Re: Former Naval Air Warfare Center (NAWC), Warminster, PA

This letter provides EPA comments on Additional Site 8 Surface Soil Sampling dated February 1, 1999, and a Verification Sampling and Analysis Plan, Vicinity of Site 8 dated February 2, 1999. These letters were telefaxed to EPA on February 8, 1999.

FIGURE 6-12
Brown & Root Environmental

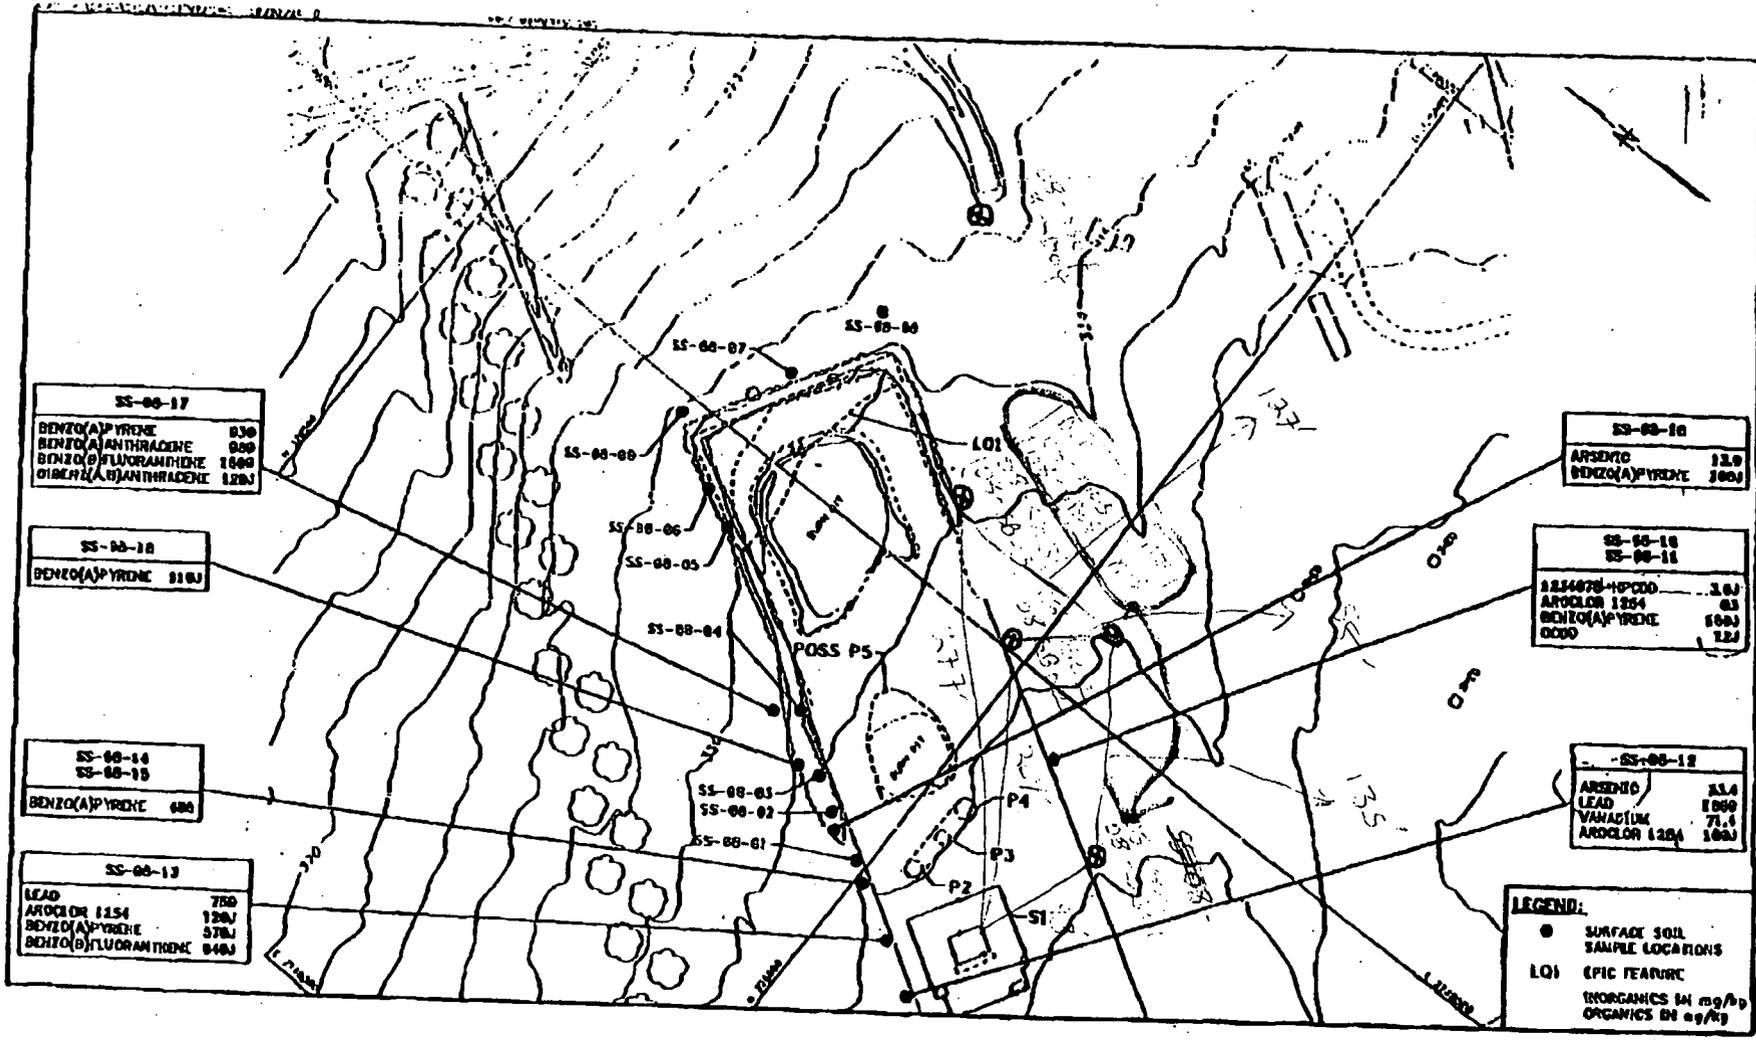
As previously requested, additional samples should be collected to ensure that contaminants of concern are not present at unacceptable levels in soils east of the runway. Recommended sample locations are provided the Attachment. Surface soil samples (per criteria identified above) and subsurface soil samples should be collected at each location. Subsurface soil samples may be collected via a hand auger advanced 3' or 4' in depth. Any observations indicative of potential contamination, e.g., odors, staining, etc., should be documented and subsurface soil samples be biased to the depth of such features or collected randomly at 2' to 4' in depth. Samples should be analyzed for lead, arsenic, vanadium and polynuclear aromatic hydrocarbons (PAHs).
